Figure 5 – Bicycle Facilities (Source: CTR, Wells and Associates, Figure 5, November 2016)

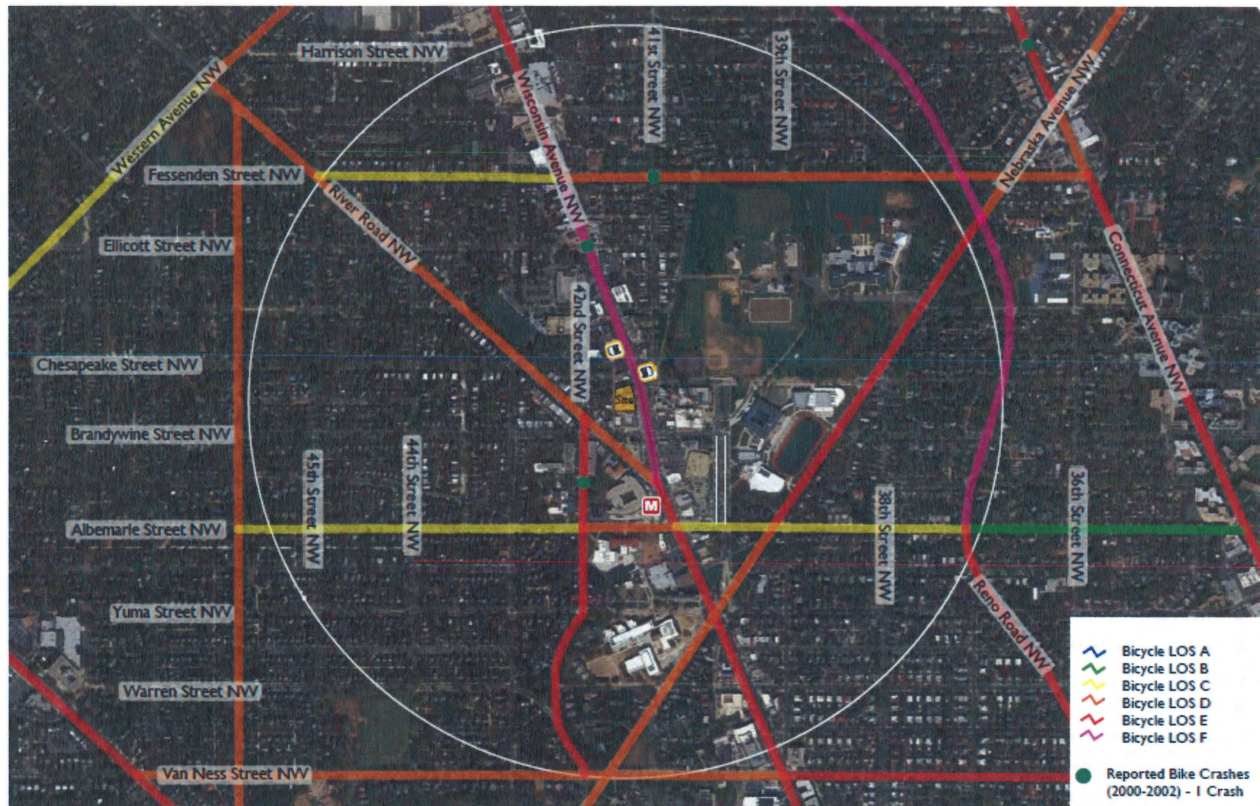
Several bicycle facilities are located near the site, including along Fessendon Street and Albermarle Street (see Figure 5).
